Type of Submission: Notice of Intent	Type of Action: Plug and Abandonment
Date Sundry Submitted: 10/11/2022	Time Sundry Submitted: 07:37
Date proposed operation will begin: 11/01/2022

Procedure Description: Hilcorp Energy Company requests permission to P&A the subject well per the attached procedures, current and proposed wellbore schematics. The Pre-Disturbance Site Visit was held on 9/29/2022 with Roger Herrera/BLM. The Re-Vegetation Plan is attached. A closed loop system will be used.

HILCORP ENERGY COMPANY
MORTON #2
NOTICE OF INTENT TO PERMANENTLY ABANDON

CONDITIONS OF APPROVAL

MORTON #2 - PROPOSED P&A SCHEMATIC

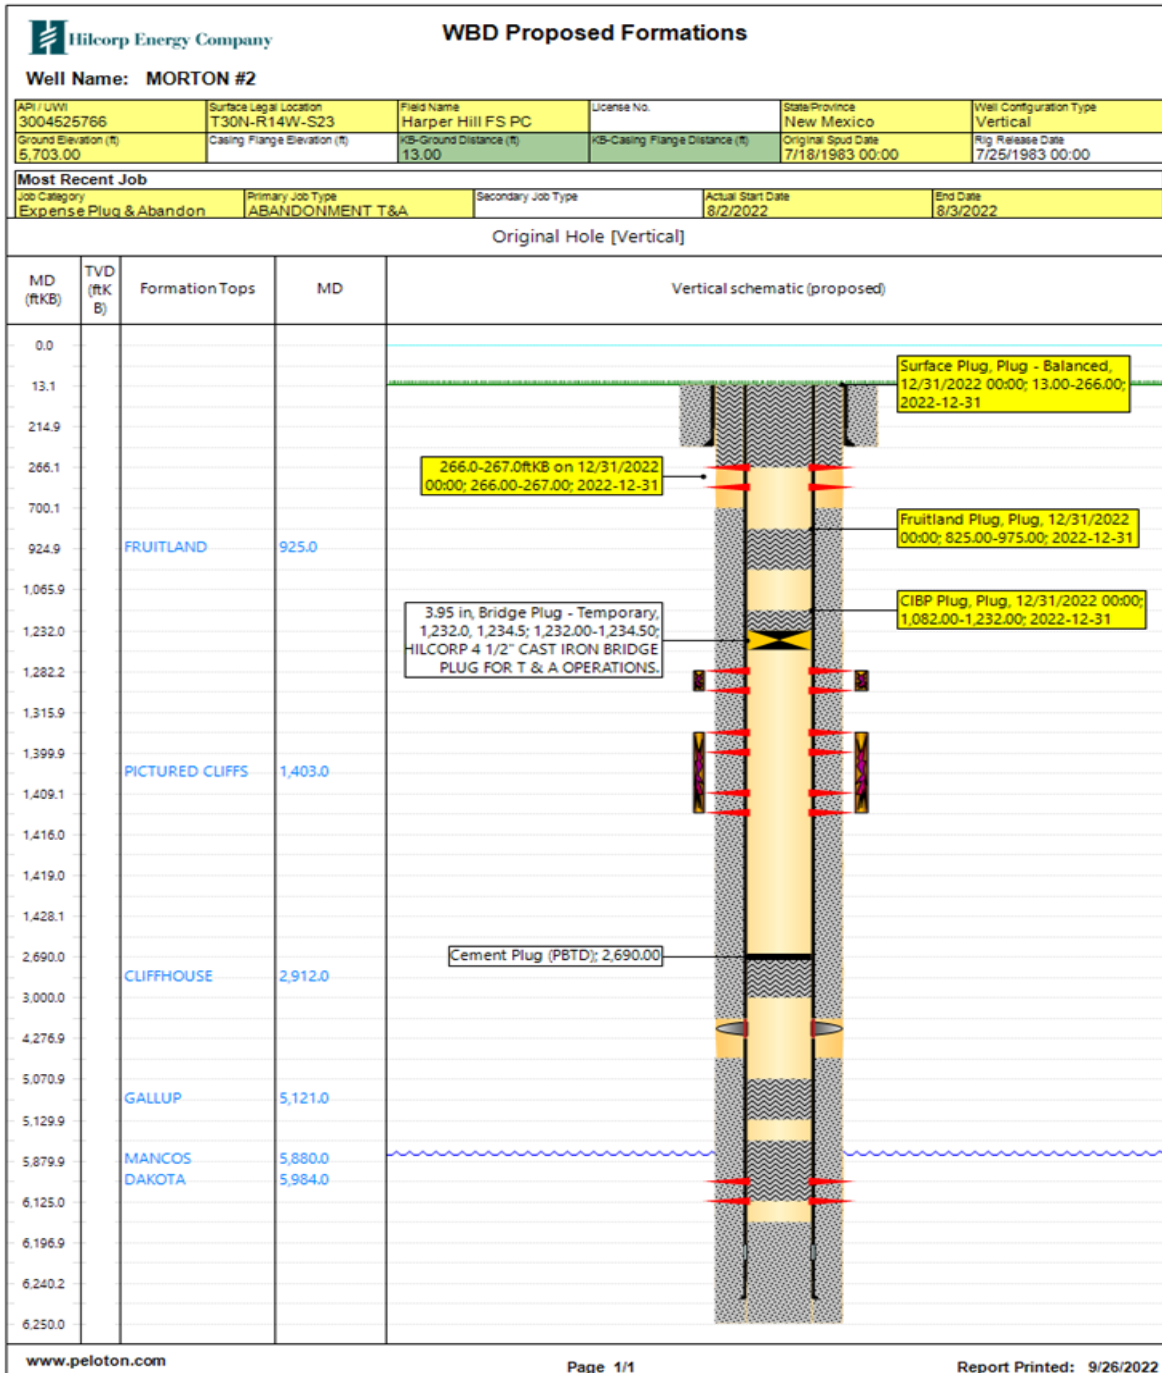
You are also required to place cement excesses per 4.2 and 4.4 of the attached General Requirements.

Created By	Condition	Condition Date
kpickford	CBL required	10/20/2022
kpickford	Notify NMOCD 24 Hours Prior to beginning operations	10/20/2022
kpickford	Adhere to BLM approved COAs and plugs. See BLM COAs and GEO report.	10/20/2022
